U.S. NUCLEAR REGULATORY COMMISSION
REGION IV

NRC Inspection Report: 50-498/92-17
50-499/92-17

Facility Name: South Texas Project Electric Generating Station (STP), Units 1
and 2

Inspection Summary

AUTO/MANUAL REACTOR TRIP CIRCUIT TYPICAL TRAIN S

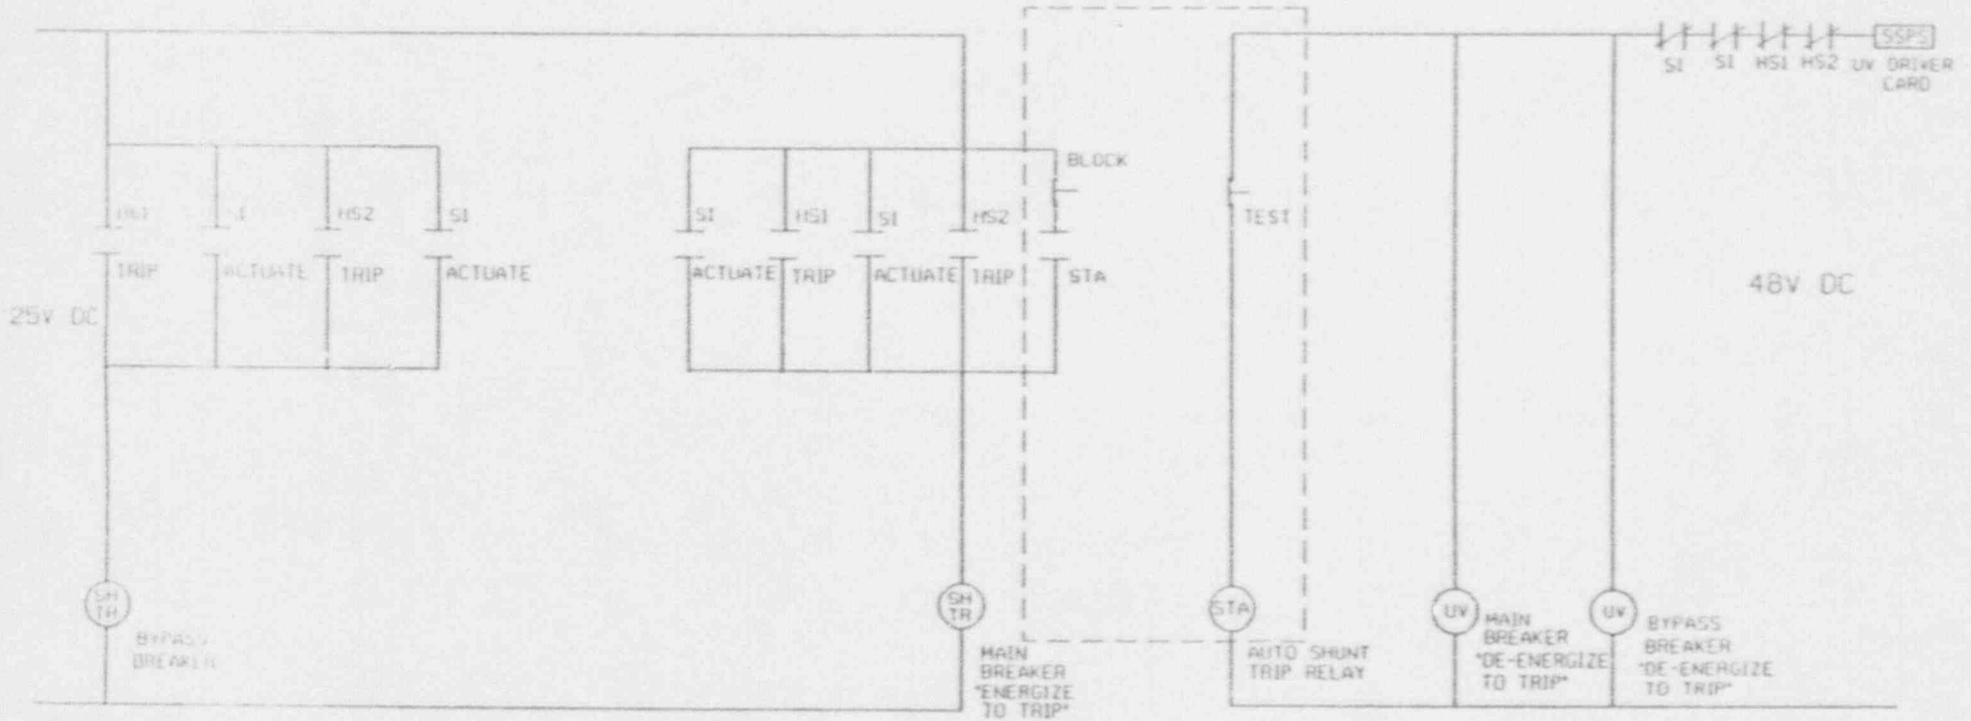
Unit 1, Note 14, requires that a Trip Actuating Device Operational Test (TADOT) of the manual reactor trip actuation undervoltage and ST circuits be performed. Note 14 requires that these circuits be tested independently. Attachment 2 of this report is a diagram that depicts an auto/manual reactor trip circuit. HS1 and HS2 are the designators for the two manual reactor trip handswitches. Each control room has two manual reactor trip handswitches with two outputs on each switch. One output actuates the Train R reactor trip breakers and the other actuates the Train S reactor trip breakers. Operation of either switch deenergizes the undervoltage coils in all the main and bypass trip breakers through the R and S logic trains. At the same time, the shunt trip coils on all breakers are energized in order to trip the breakers.

The portion of the diagram within the dotted line represents the modification which resulted from the Salem Anticipated Transient Without Scram (ATWS) event. This modification was installed in the main breaker ST circuit as required by Generic Letter 83-28, "Required Actions Based on Generic Implications of Salem ATWS Events." Item 4.3 of Generic Letter 83-28 established the requirements for the automatic actuation of a ST attachment for Westinghouse plants. The automatic ST modification was based on the generic design developed by Westinghouse under the sponsorship of the Westinghouse Owners' Group. The generic design was submitted to the NRC on June 14, 1983, and a Safety Evaluation Report was issued on August 10, 1983, endorsing the design. The modification provides for automatic actuation of the reactor trip breaker ST mechanism on a condition which deenergizes the undervoltage coils. The "Block" designation within the dotted line represents the "Block Auto Shunt Trip" switch. This switch is intended to be used during the TADOT voltage measurements to preclude sensing the application of power to the ST coil via the automatic ST feature. This switch must be depressed in order to independently verify the operability of the ST and undervoltage trip circuits for the manual reactor trip function, as required by TS for the main trip breakers. The ST circuit on the bypass breakers can be tested independently by measuring the voltage across the ST coils.

During a biennial review of Surveillance Procedure IPSP03-RS-0002, Revision 2, "Manual Reactor Trip TADOT," a system engineer determined that the procedure did not independently test the manual ST function because the "Block Auto Shunt Trip" switch was not required to be manipulated during the TADOT. This step is necessary in order to test the set of contacts that directly completes a current path to the ST device, which trips the breaker. As a result, these contacts had not been independently tested by the manual reactor trip TADOT procedure. The system engineer also noted that the surveillance procedure failed to independently verify operability of the ST circuit on the reactor trip bypass breakers because voltage was not measured across the bypass breaker ST coils during the TADOT.

The failure to satisfy the requirements of TS Surveillance Requirement 4.3.1.1 is an apparent violation (498;499/9217-01). The licensee has initiated actions to revise the TADOT procedures in order to properly perform the TADOT during the next shutdown of each unit.
